KAGRA Sensitivity for Observation Scenario Paper 2018

Yuta Michimura

Department of Physics, University of Tokyo

Proposal for Update v20181005

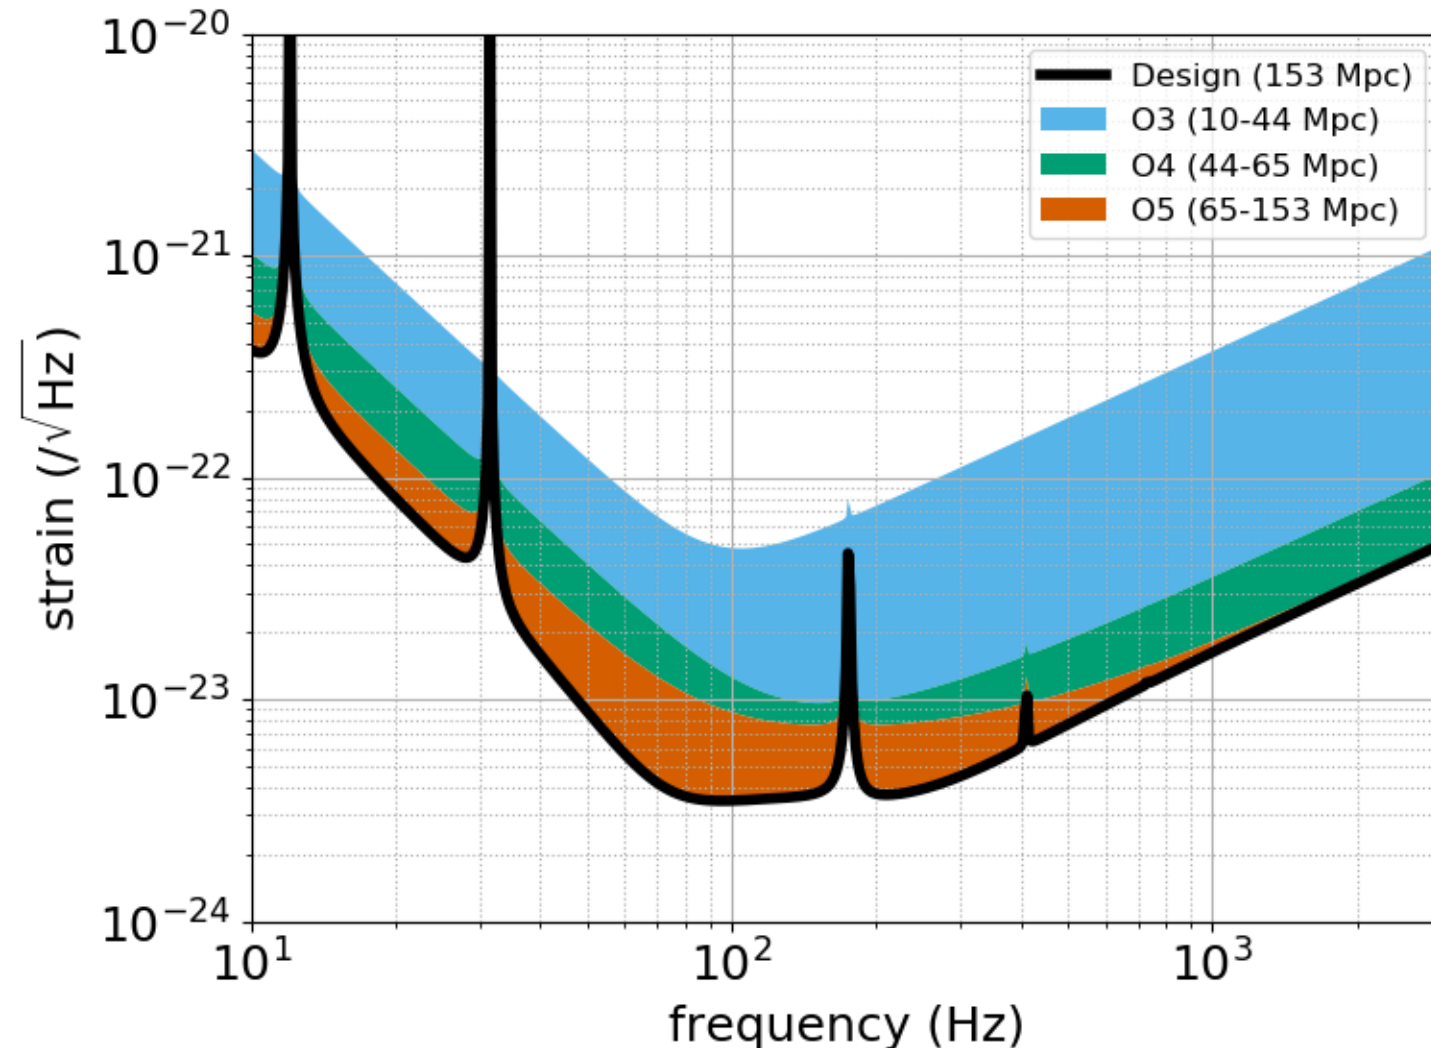
- 44 Mpc for O3 high sounds a bit too ambitious compared with 25 Mpc for Early high (2019.4-2020.3) in previous version
- People might think we should aim for the design sensitivity for O4
- DRSE in O4 might be too ambitious
